Whitehouse Planning Commission Meeting Notice

**STAFF REPORT
PLANNING COMMISSION
PRELIMINARY PLAT APPLICATION
11320 ARCHBOLD WHITEHOUSE – STAFF REPORT 03-2026
July 6, 2026**

PRELIMINARY DRAWING OF Country Meadows South Plat 1

**STAFF REPORT
PLANNING COMMISSION
Revised Site Plan Review 04-2026
Whitehouse Square Townhomes
July 6, 2026**

Original

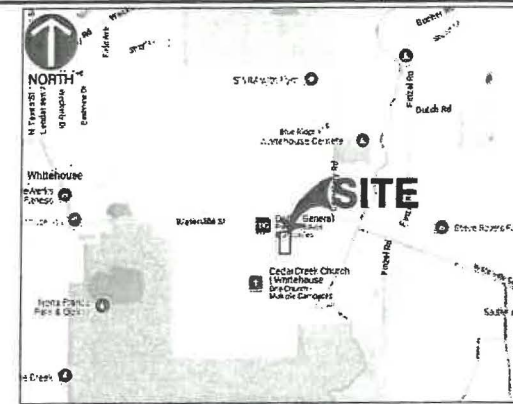
All proposed units appear to show front yard setbacks (20 feet) that exceed the Maximum Lot Width requirement. Therefore, variances will be required for all 33 proposed units. All units appear to meet the Minimum Rear Yard requirement. The developer should confirm that the Minimum Side Yard requirement is met for each end unit.

Although the plans do not specify the number of stories, the developer stated during a meeting with staff that all 33 units are two stories and that all units share at least one common wall with another unit. Additionally, the plans show that lots 1-3 and 31-33 have 1,100 sf footprints, lots 4-15 have 1,344 sf footprints, and lots 16-30 have 902 sf footprints. Due to lots 16-30 not meeting the minimum floor area requirement of 1,000 sf, variances will be required.

12. Will there be a designated park and will the "central focus" provision be satisfied?
13. The drawing shows proposed walking paths/sidewalks on one side of Whitehouse Square Boulevard, which meet the requirements of this section, but only one side of Jameson Drive, which does not meet the requirements.

1252.06 – To allow front yard setbacks greater than five feet

1252.07 – Variances will be required if each floor is less than 1,000 square feet (e.g., lots 16-30)
